ASSESSMENT REPORT

Section 75W Modification Bay Ridge Estate Residential Subdivision, Eurobodalla Local Government Area (DA 172-7-2005 MOD 3)

Figure 4: Proposed Revisions to the Layout of Stage 2B (approved lot layout in red, proposed lot layout in blue)

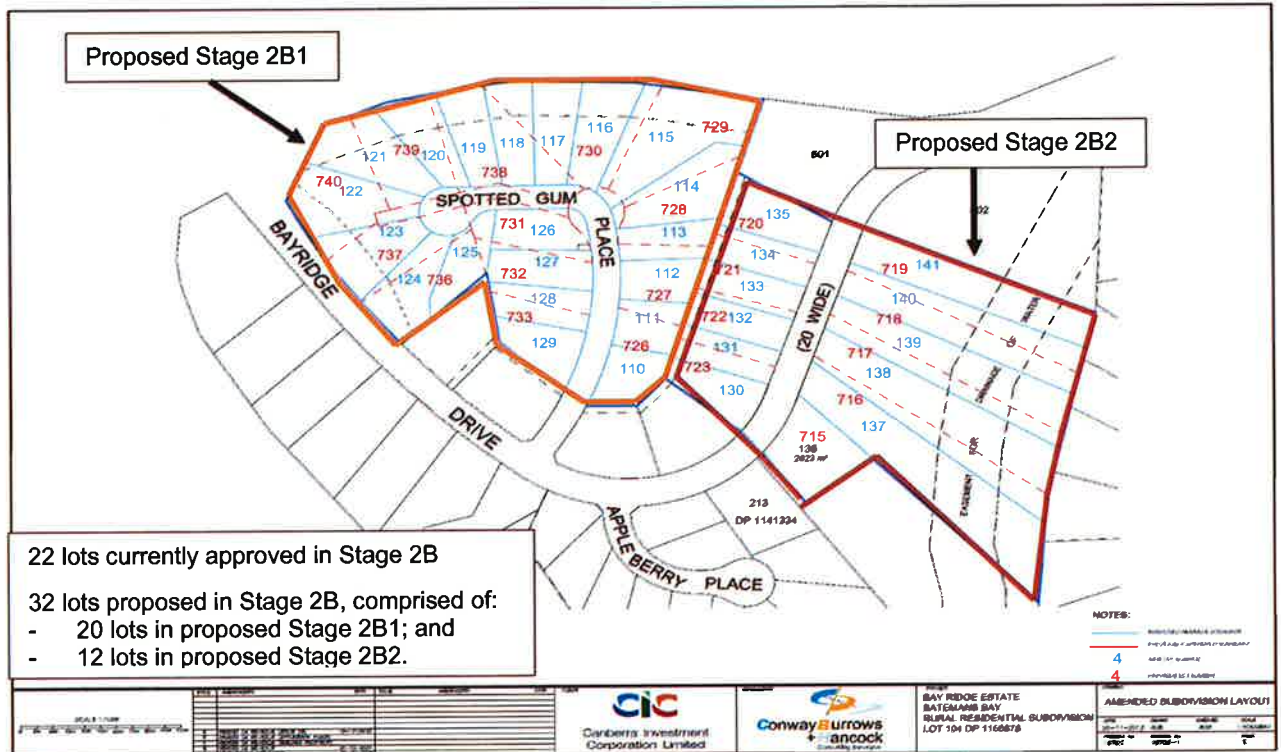
The modification request seeks approval to increase the number of lots within Stage 2B from 22 to 32 lots. In addition, the application seeks approval to:

- specify that the building envelopes for lots within stage 2B can be less than 400 m², provided that they meet the performance criteria contained in the *Eurobodalla Residential Zones Development Control Plan*; and
- undertake the subdivision works within Stage 2B in two stages (stages 2B1 and 2B2).

On 20 July 2012, the Eurobodalla LEP was gazetted and rezoned the site 'R5 - Large Lot Residential'. In this regard, the Lot Size Map referenced in clause 4.1 of the Eurobodalla LEP permits new lots within the Bay Ridge Estate to achieve a minimum lot size of 1,500 m².

In addition, on 28 November 2011, the *Eurobodalla Residential Zones Development Control Plan* (Eurobodalla DCP) commenced operation. The Eurobodalla DCP establishes setbacks for residential lots under 2,500 m² using performance based criteria. In this regard, in order to achieve compliance with the DCP a 1,500 m² lot would require a minimum building envelope of between 350 m² and 400 m².

The proposed lots in stages 2B1 and 2B2 range in size between 1,500 m² and 6,855 m² in area, and are therefore consistent with the minimum lot size requirements of the LEP. In addition, the application seeks to amend Condition 1.1B to enable the creation of building envelopes less than 400 m² in stages 2B1 and 2B2, provided that they meet the performance based requirements of the Eurobodalla DCP.

The Department has reviewed the proposed modifications to the subdivision layout and has concluded that the proposed modifications are acceptable for the following reasons:

- the proposed lots and building envelopes within Stage 2 are consistent with the Council's LEP and DCP requirements;
- the application would not result in any additional clearing beyond that approved under the original development application; and
- the proposed lots can be serviced in accordance with the servicing strategy approved under the original development consent.

Figure 5: Building Envelope for Lot 136

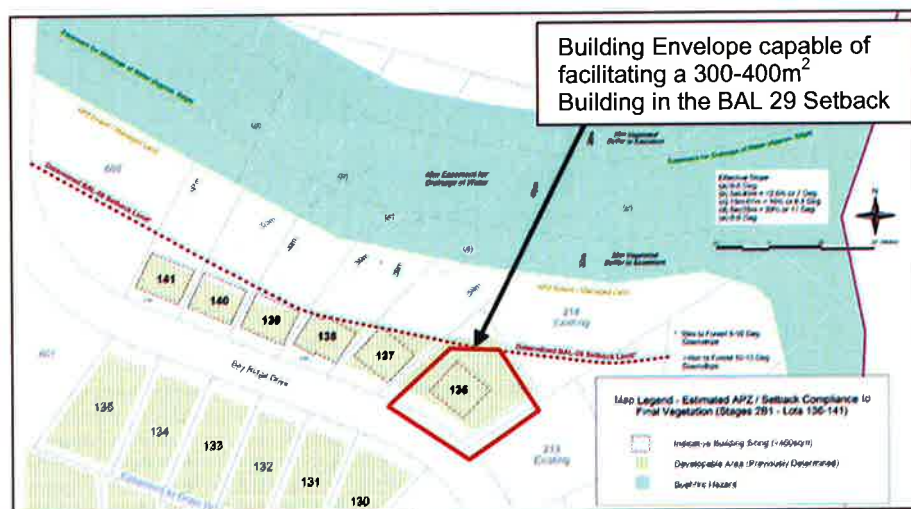
Both the Council and the RFS advised that the proposed lots within stages 2B1 and 2B2 may increase the bushfire attack classification from BAL 29 to BAL FZ. In addition, the Council requested that the Department impose a condition requiring the development to achieve a BAL of 40 or lower.

- APZs of 39 metres for lots 136-141 and 18 metres for lots 115-122 meet a BAL 29 classification under the Australian Standard, and this is a reduction from the previous assessment of a BAL 40 classification negating the need for additional clearing in Stage 2B;

- whilst the building envelopes for lots 115-122 and Lot 136 would technically extend into the BAL 40 limit, a 300 to 400 m² building could reasonably be sited within the building envelope, and setback to the extent required to achieve a BAL 29 classification (see **Figures 5 and 6**); and

The Department has assessed the supplementary bushfire advice in conjunction with the RFS and has concluded that the proposed lots can achieve a BAL 29 classification without the need for additional clearing. The Department has recommended conditions of approval to ensure a BAL 29 classification is achieved.

Figure 7 (top) Staging Plan and Figure 8 (bottom) Archaeological Sites Map Showing the Relationship between Archaeological Areas

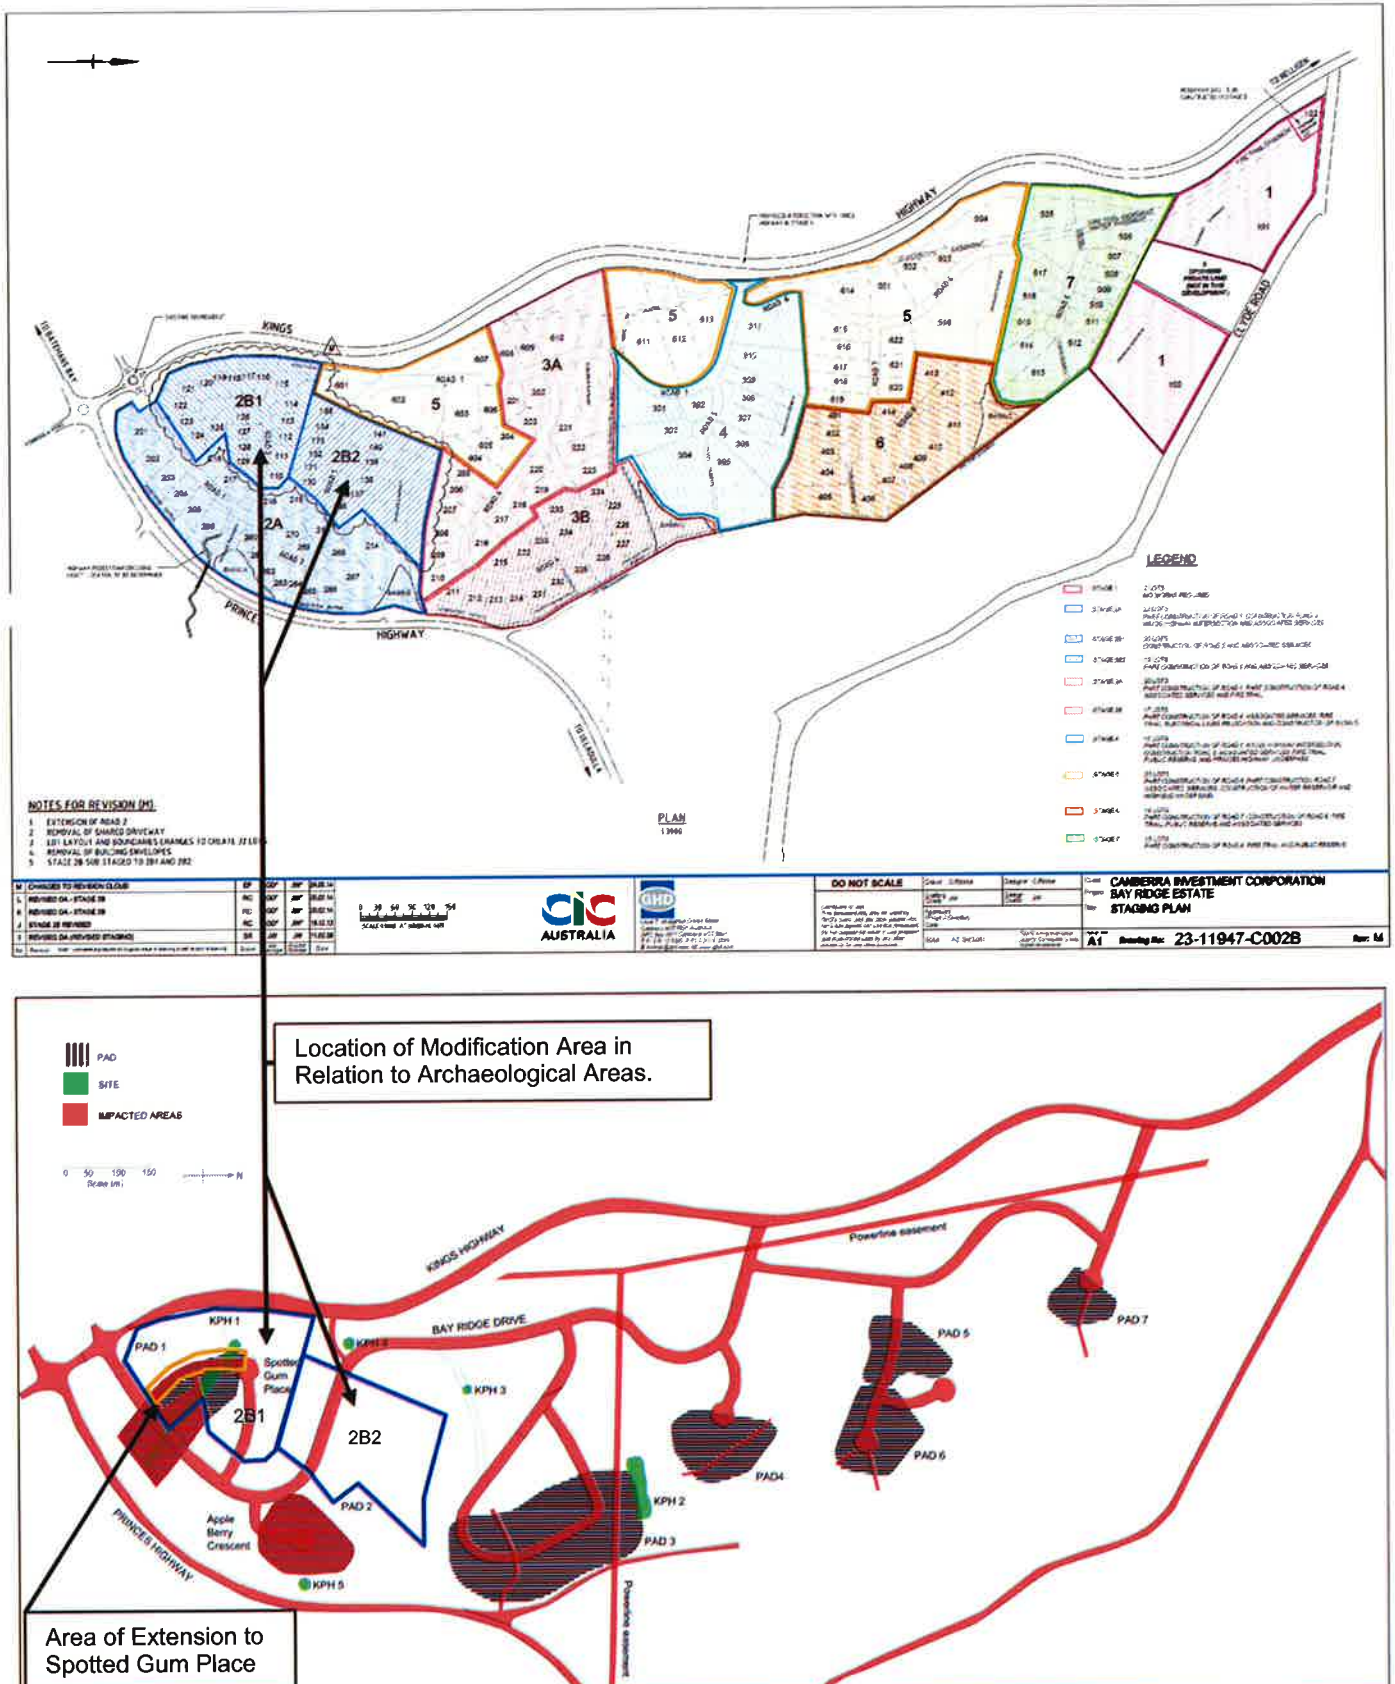
As previously outlined, portions of the site have been cleared to facilitate the construction of the approved road network, and the OEH sought clarification to determine whether these works were undertaken in accordance with Section 90 permit 2099.

The Proponent's RTS included an Archaeological Site Assessment to address the issues raised by the OEH. In this regard, the assessment concluded that the following relics have been destroyed or removed in accordance with Section 90 permit 2099:

- KPH 1 and PAD 2 have been destroyed; and
- PADs 1,3,4,5,6, and 7 have been partially destroyed.

Based on the above, it is clear that the proposed works in Stage 2B, including the extension to Spotted Gum Place, will take place on areas of KPH 1 and PAD 1 that have already been destroyed (see **Figures 7 and 8**). As such, the Department accepts that the proposed

extension of Spotted Gum Place will not result in the disturbance or removal of any intact relics or PADs.

As the proposed modification is a transitional Part 3A project, the Department cannot require the Proponent to obtain a new section 90 permit. However, the Department has recommended a new condition (Condition 1.13a) requiring the Proponent to prepare an Aboriginal Cultural Heritage Assessment outlining the impacts of the works on any relics or PADs, and identify appropriate conservation or mitigation measures to manage any impacts. This report must be prepared in consultation with the OEH, and approved by the Secretary prior to the Proponent undertaking any new excavation works outside of Stage 2B.

The Department is satisfied that subject to the imposition of the condition outlined above, the application would not result in any adverse archaeological impacts.
